**Sub-Committee of Experts on the
Transport of Dangerous Goods**

**Issues relating to the Globally Harmonized System
of Classification and Labelling of Chemicals: use of
the Manual of Tests and Criteria in the context of
the GHS**

**Use of the Manual of Tests and Criteria in the context of the
GHS**

**Transmitted by the Chairman of the Working Group on Explosives of
the Sub-Committee of Experts on the Transport of Dangerous Goods
(TDG Sub-Committee) on behalf of the Working Group**

Figure 20.1-(a): FLOW CHART SCHEME FOR SELF-REACTIVE SUBSTANCES AND ORGANIC PEROXIDES

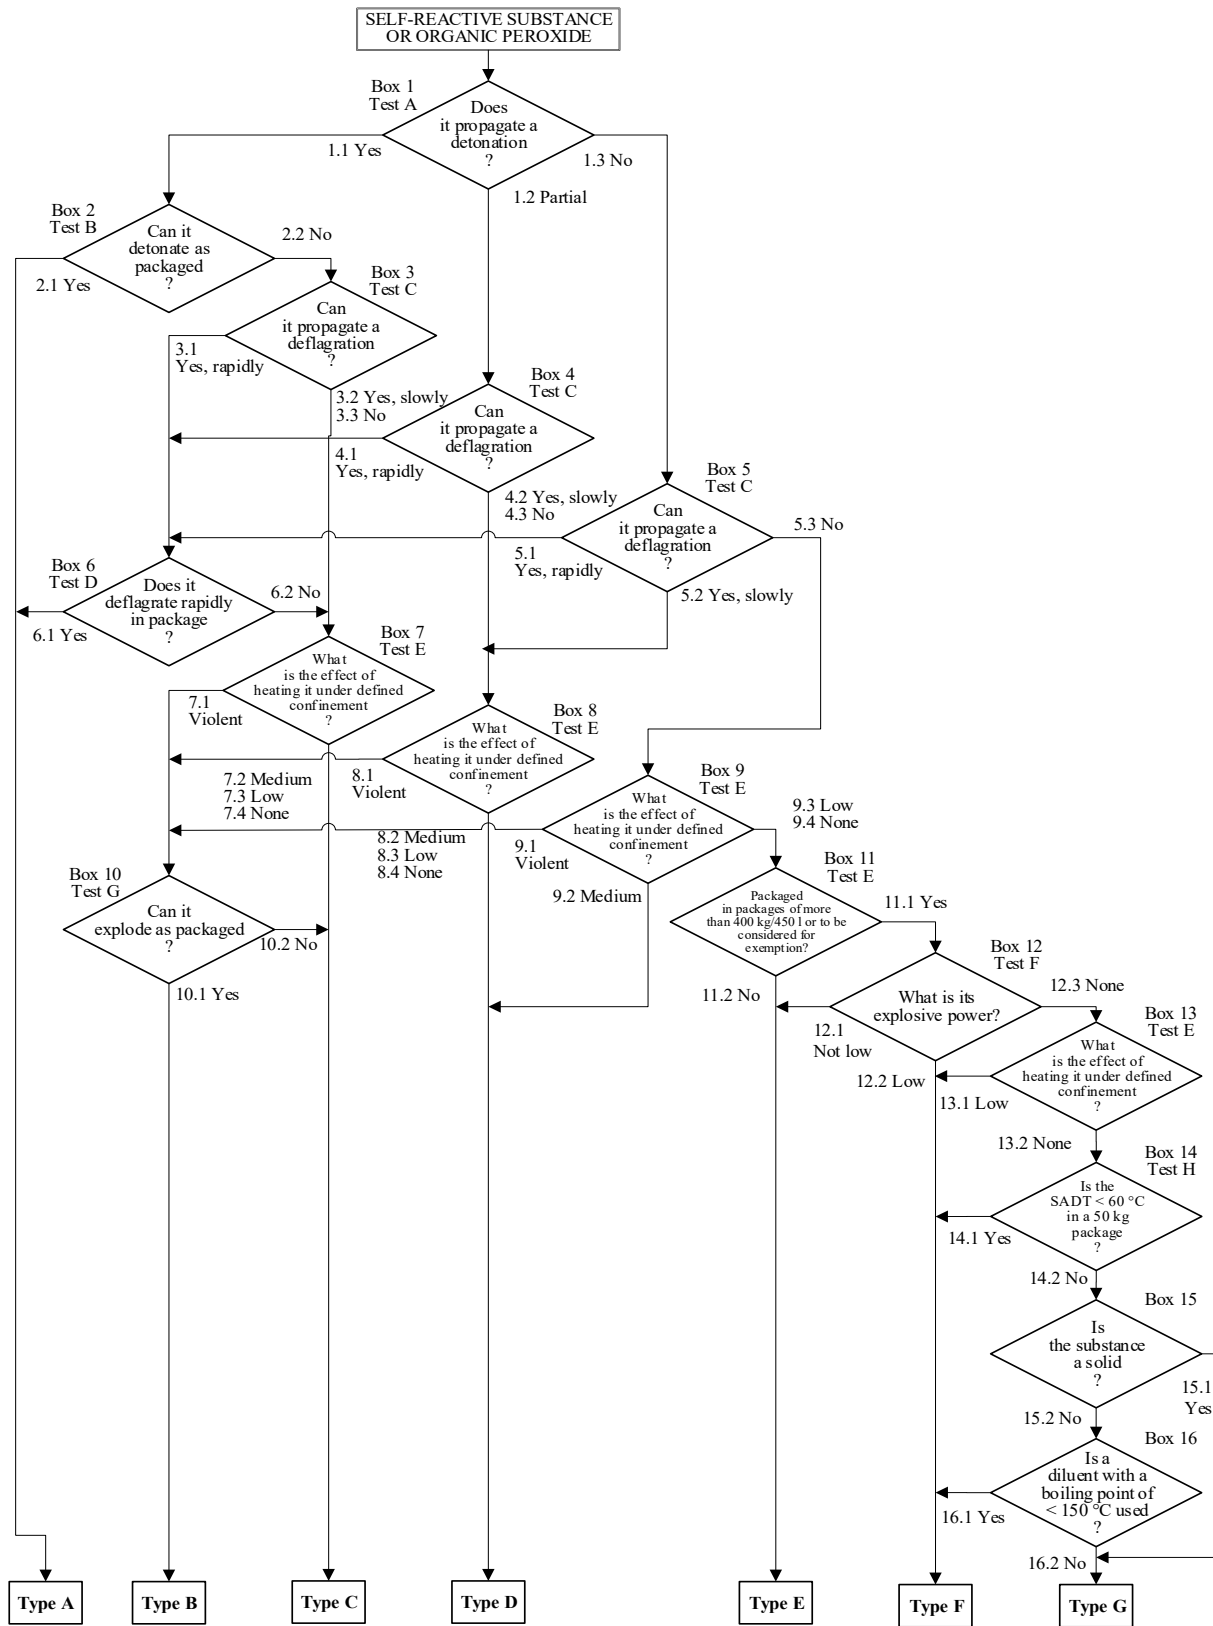
Figure 20.1 (b): ~~FLOW CHART SCHEME FOR SELF-REACTIVE SUBSTANCES AND ORGANIC PEROXIDES (cont'd)~~

- (a) Any self-reactive substance which, ~~as packaged, can detonate or deflagrate rapidly, as packaged for transport, should be prohibited from transport under the provisions for self-reactive substances of Division 4.1 in that packaging~~ (will be defined as self-reactive substance †Type A; exit box A of Figure 20.1);

- (b) Any self-reactive substance possessing explosive properties and which, ~~as packaged for transport, neither detonates nor deflagrates rapidly, but is liable to undergo a thermal explosion in that package, should also bear an "EXPLOSIVE" subsidiary risk label. Such a substance may be packaged in amounts of up to 25 kg unless the maximum quantity has to be limited to a lower amount to preclude detonation or rapid deflagration in the package~~ (will be defined as self-reactive substance †Type B; exit box B of Figure 20.1);

- (c) Any self-reactive substance possessing explosive properties ~~may be transported without an "EXPLOSIVE" subsidiary risk label~~ when the substance, as packaged, ~~(maximum 50 kg) for transport cannot detonate or deflagrate rapidly, or undergo a thermal explosion~~ (will be defined as self-reactive substance †Type C; exit box C of Figure 20.1);

- (ii) does not detonate at all, deflagrates slowly and shows no violent effect when heated under confinement; or
 - (iii) does not detonate or deflagrate at all and shows a medium effect when heated under confinement;
~~may be accepted for transport in packages of not more than 50 kg net mass~~ (will be defined as self-reactive substance †Type D; exit box D of Figure 20.1);

- (e) Any self-reactive substance which, in laboratory testing, neither detonates nor deflagrates at all and shows low or no effect when heated under confinement ~~may be accepted for transport in packages of not more than 400 kg/450 litres~~ (will be defined as self-reactive substance †Type E; exit box E of Figure 20.1);

- (f) Any self-reactive substance which, in laboratory testing, neither detonates in the cavitated state nor deflagrates at all and shows only a low or no effect when heated under confinement as well as low or no explosive power ~~may be considered for transport in IBCs or tanks~~ (will be defined as self-reactive substance †Type F; exit box F of Figure 20.1); ~~for additional provisions, see~~
